Work Order ID 108680

Item Name: Crosstube Turning Detail

DRAWING NO. D412-664-243	TITLE CROSSTUBE ASS'Y (412 HI AFT)	REV. E	DART AEROSPACE LTD ENGINEERING ORDER		D.E.O. NO. D412-664-243-E-2	SHEET NO. SHEET 1 OF 1	SCALE NTS
DRAWN QP	CHECKED ASS	MFG. APPR. RE	APPROVED MP		DE APPR. H		
DATE 11.09.07	DATE 11.09.19	DATE 11.09.19	DATE 11.09.19		DATE 11.09.19

DRAWING NO. D412-664-243	TITLE CROSSTUBE ASSEMBLY (412 HI AFT)	REV. E	DART AEROSPACE LTD ENGINEERING ORDER		D.E.O. NO. D412-664-243-E-4	SHEET NO. SHEET 1 OF 3	SCALE NTS
DRAWN <i>MP</i>	CHECKED <i>MP</i>	MFG. APPR. <i>MP</i>	APPROVED <i>MP</i>		DE APPR. <i>MP</i>		
DATE 12.08.21	DATE 12.08.30	DATE 12.08.30	DATE 12/8/30		DATE 12.08.30

**D412-664-243
ASSEMBLY DETAIL**

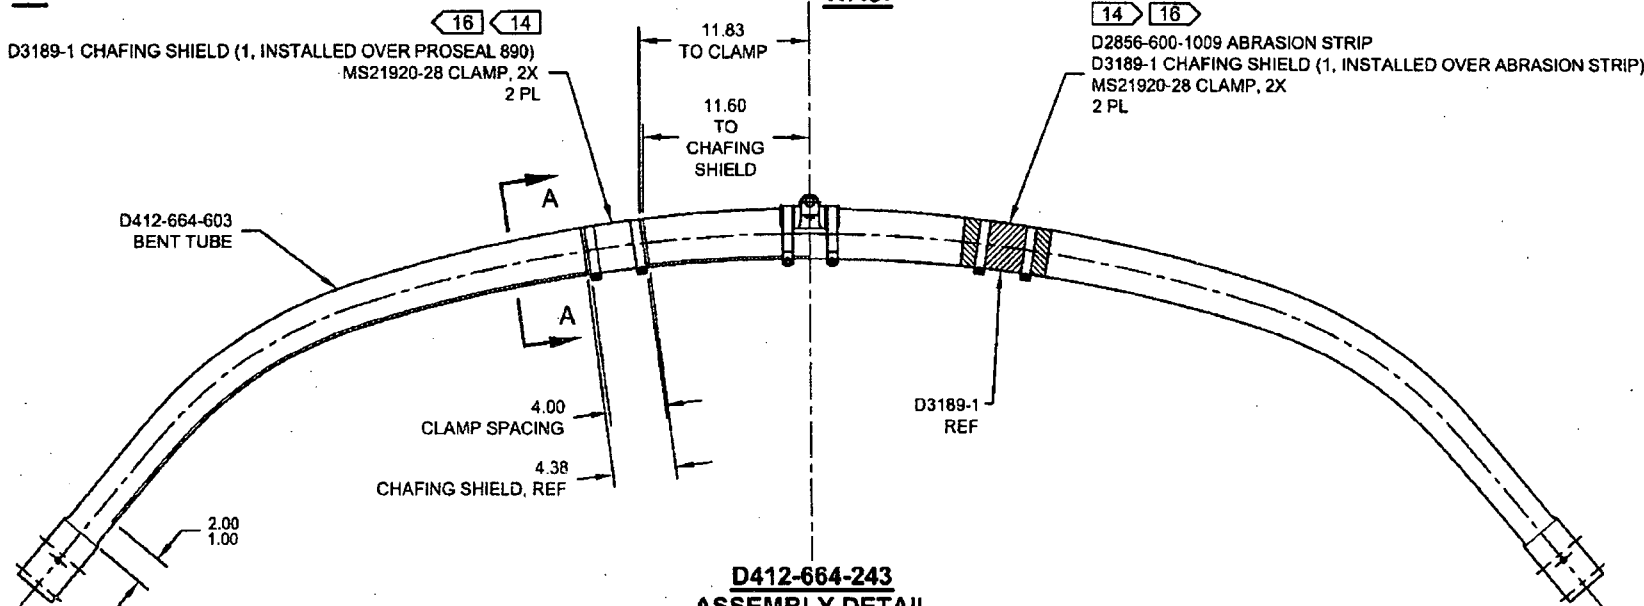
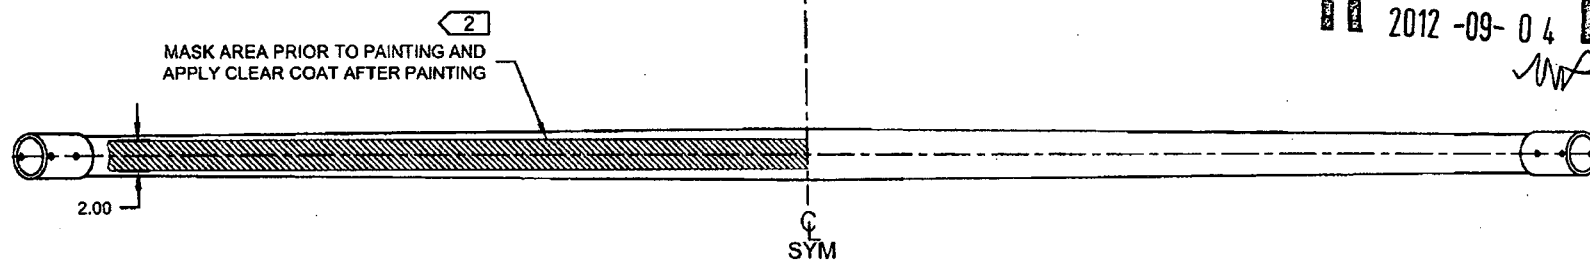
REMOVED ABRASION STRIP IN FAVOR OF A THIN LAYER OF PROSEAL 890. UPDATE INSTALLATION OF CHAFING SHIELDS AND REDUCE TORQUE TO 40-50 IN-LBS. THIS ENGINEERING ORDER SUPERCEDES DEO D412-664-243-E-1.

D3189-1 CHAFING SHIELD (1, INSTALLED OVER PROSEAL 890)
MS21920-28 CLAMP, 2X
2 PL

D2856-600-1009 ABRASION STRIP
D3189-1 CHAFING SHIELD (1, INSTALLED OVER ABRASION STRIP)
MS21920-28 CLAMP, 2X
2 PL

IS:
